Design, Estimating, and Construction Review Report

Kern Fan Groundwater Storage Project

Interior Region 8: Lower Colorado Basin

Figure 2 – Total Subtotal Cost

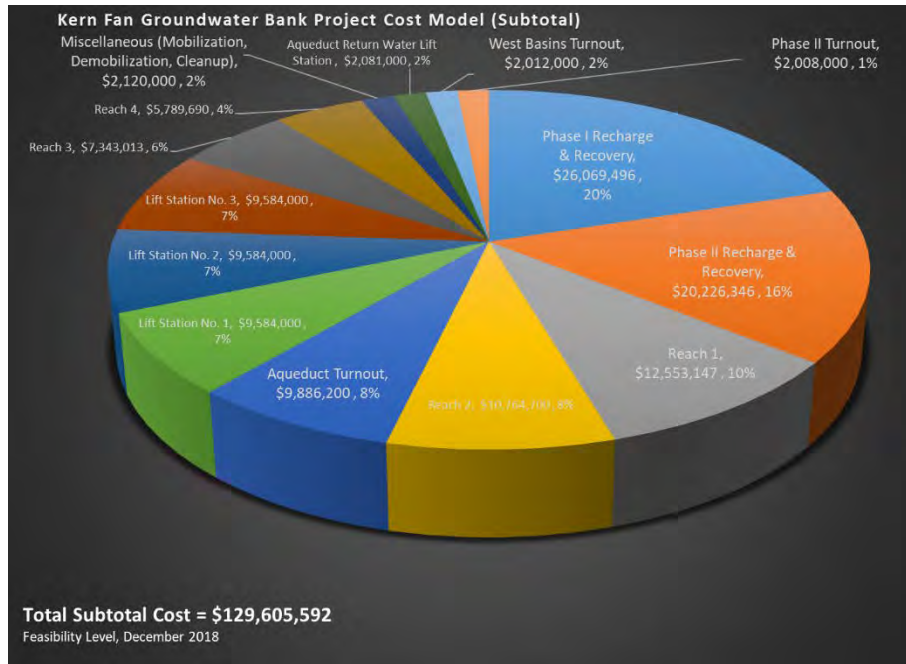
Subtotal cost of the Project is shown in Figure 2 below; total construction cost is shown in Figure 3. Project cost charts were not updated based on the information provided in the responses in Appendix D.
